# BARTLETT POOL – DIVE STAND INSTALLATION ANALYSIS

Anchorage, AK

**Report by:** Cole Henry, P.E.

**Report sent:** October 23, 2024

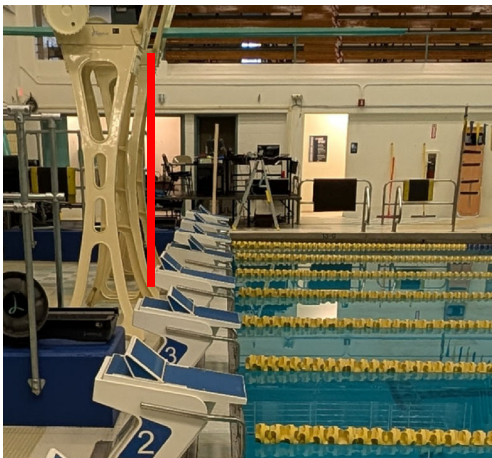
The code issues noted are related to deck clearances between the 1M dive stand and the natatorium wall. However, this pinch point condition may have existed with the old installation, and could be potentially considered “grandfathered” by the health department.

During new designs, C-H typically calls for a minimum of 4'-0” between the rear extent of dive stands and the natatorium wall. However, depending on the interpretation of the health department, the space between the rear ladder for the 3M and the natatorium wall may be a non-issue. In some jurisdictions, these clearances between the rear ladder and natatorium wall are overlooked for 3M dive stand installations, since lifeguards and swimmers can still safely access the entire pool perimeter by traveling underneath the 3M stand.

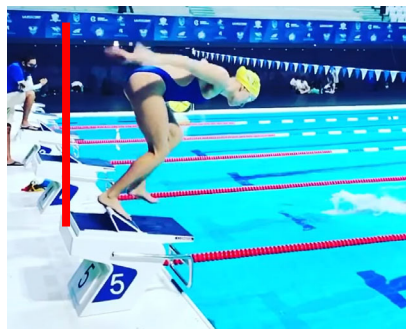
For traditional flat start and relay exchange motions during competitive swimming events, swimmer's arms or legs will not encounter the dive stand equipment. For a flat start, swimmers' arms and legs never extend past the rear of block. See installation image below compared with Olympian Anthony Ervin preparing for a flat start, with a red line indicating the vertical plane of the rear starting block edge.

With the innovative and explosive stepover relay start, swimmers swing their arms as they “step over” the track start wedge of the block to gain momentum as they dive into the water. Local swim coaches are concerned about swimmers' arms contacting the dive stand. Three images are provided below from an elite swim coach (David Marsh) social media page, with a red line indicating the vertical plane of the rear starting block edge. The images indicate that the arms do not traditionally pass the rear edge of the block. This is because swimmers are already forward with their feet as the arm swinging motion is executed.

However, C-H recommends that stringent operational procedures must be administered by staff to require all 1M and 3M springboards to be hinged upwards during any swim practice or competition to adhere to the USA Swimming Rulebook. In addition, bolded signage should be attached to platforms 4 and 5 stating that the blocks may not be climbed from the rear edge. In addition, padding can be added to the underside of the 3M dive stands. These actions will further prevent the possibility of head collisions with the stands.
